**ADDENDUM NO 1
TO
CONTRACT DOCUMENTS
FOR
SERWTP Influent Vault Rehabilitation**

DISTRICT PROJECT NO.: 4367

SERWTP INFLUENT VAULT REHABILITATION

DATE	01/23/2025
PROJECT NUMBER	4367
DRAWING NUMBER	M2
SHEET NUMBER	8 OF 15

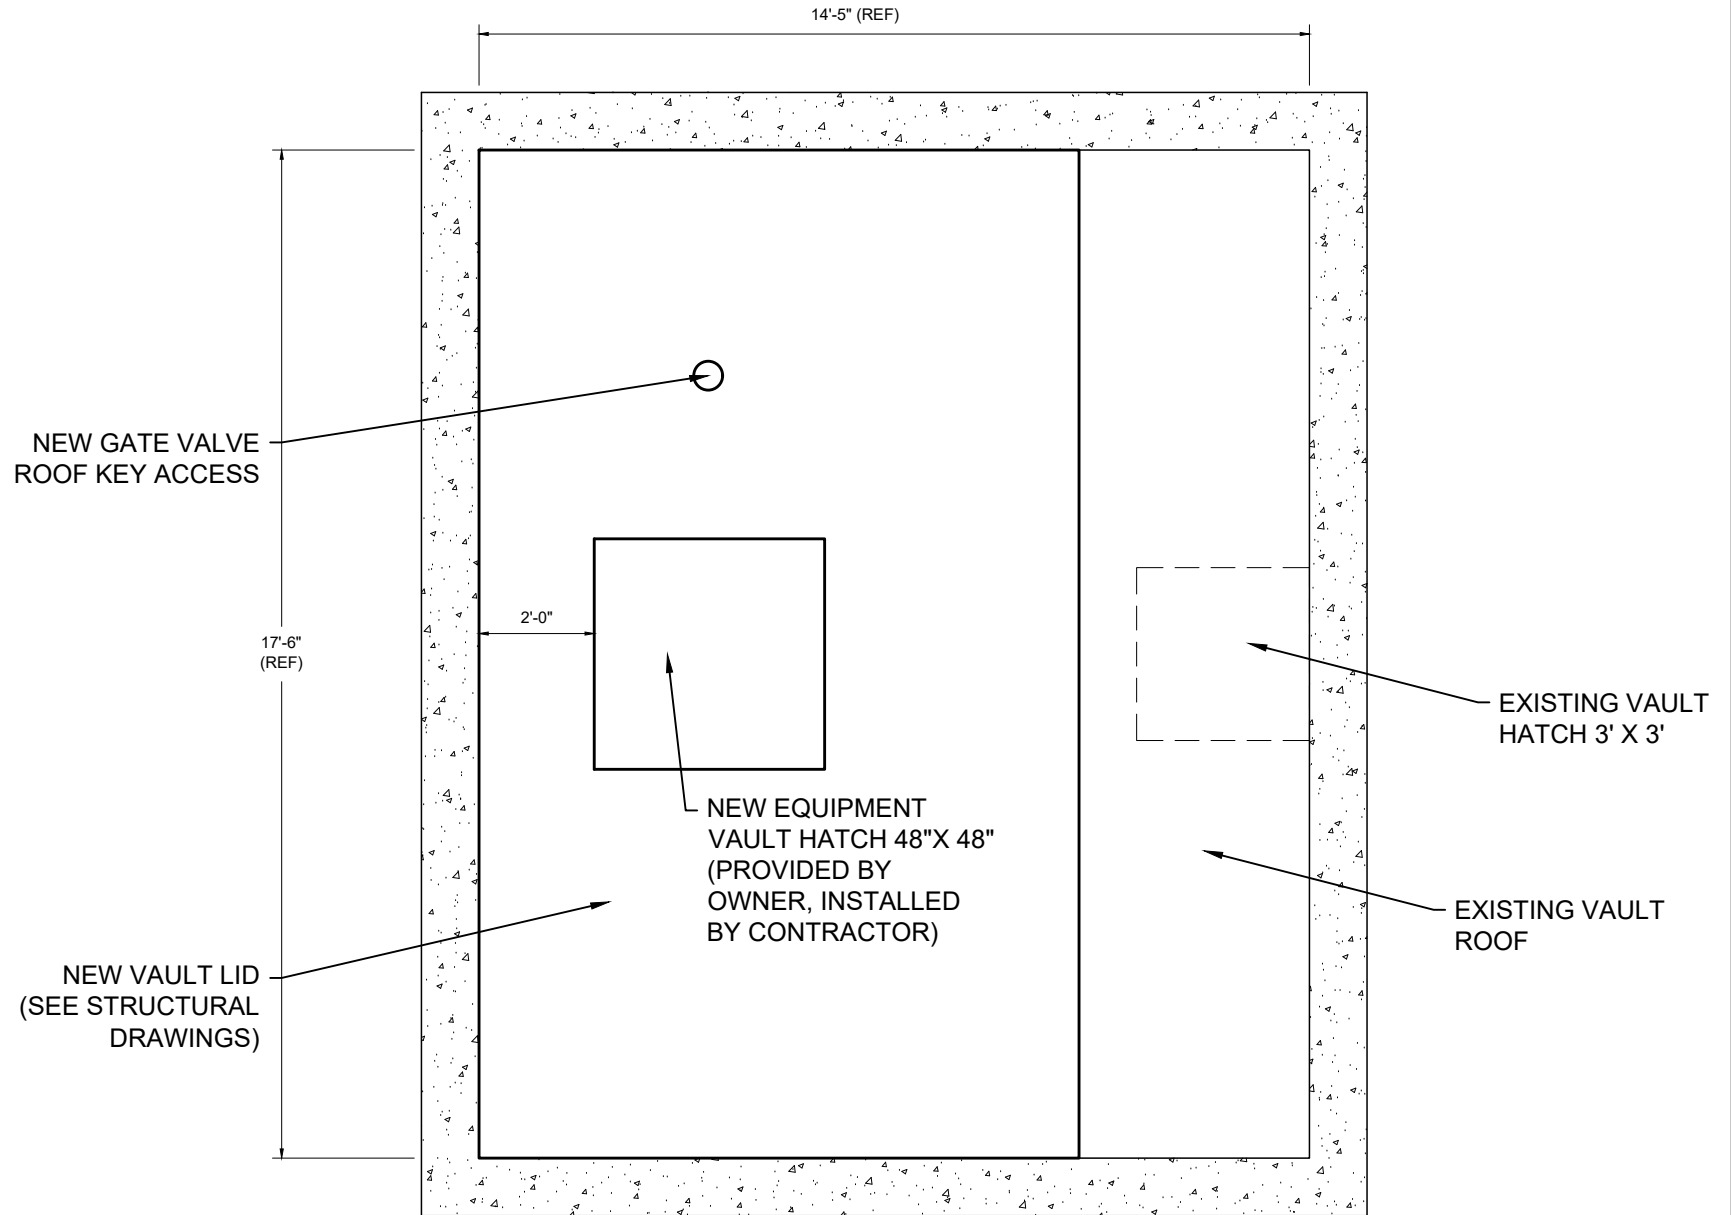
2. Changes to Drawings:
 - A. Drawing M-2 has been updated and is attached to this addendum to include a seal coat layer to be added on the vault roof.
 - B. Drawing M-3 has been updated and is attached to this addendum to display the correct number of actuators to be added to the vault gallery. Note: The bid schedule is unchanged and did show the correct number of actuators.

GENERAL NOTES:
 1. SEAL COAT VAULT ROOF SURFACE WITH BITUMINOUS SURFACE COATING COMPOUND.
